PRESERVE ROSS VALLEY

February 2, 2016

RE: Marin Catholic's Application for Stadium Lighting

Figure 1: Comparison of 130 Corte Balboa Test Results by Grzebik and Rosen

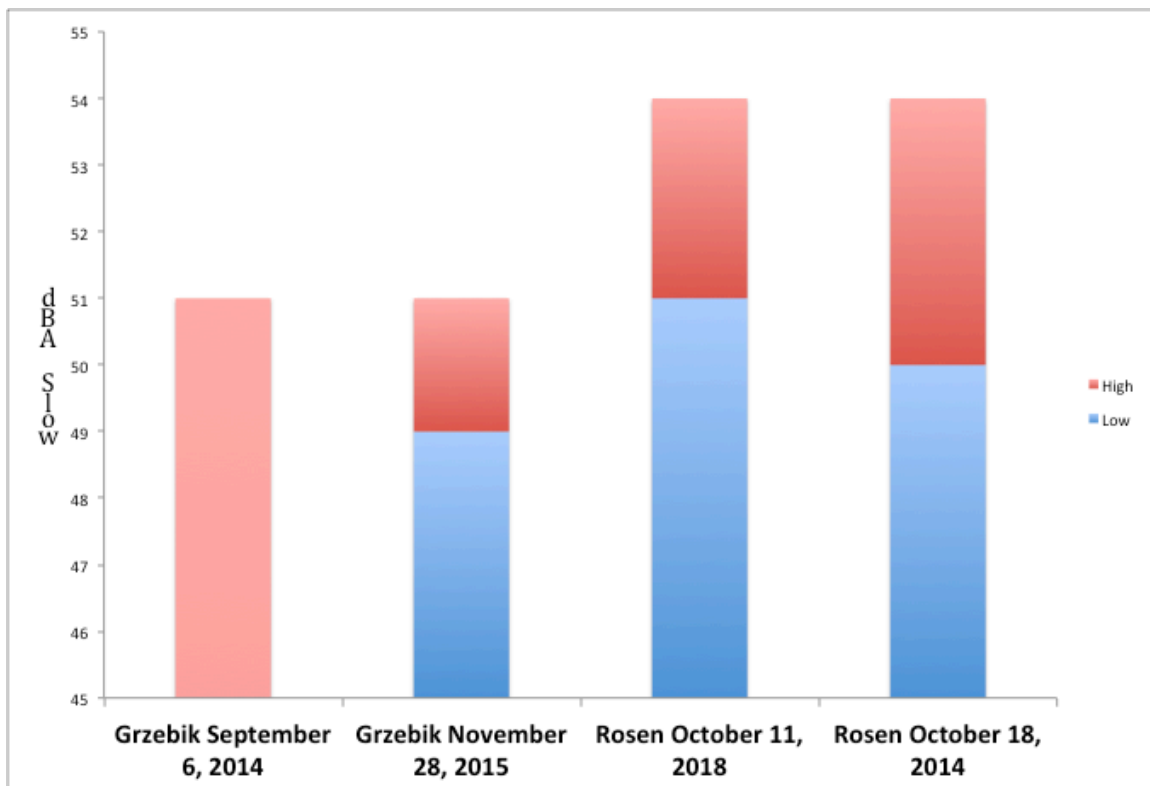
- I have created the following graphs comparing the noise tests of Rosen from the appropriate testing locations at these properties and Grzebik's undisclosed testing locations. The bars show the measurement of sound at each location. Each reports the dBA slow test results, which I understand are a primary metric in the Marin County Sound Element Guidelines for assessing noise from a proposed project. When there was a range, the blue shows the minimum while the red area indicates the range to the maximum. The data clearly show that Rosen systematically measured much higher noise levels than Grzebik.

- Without a clarification regarding the precise locations that Grzebik selected when he took his measurements, the application should be deemed incomplete as this data may be measuring two different locations from an acoustic perspective.
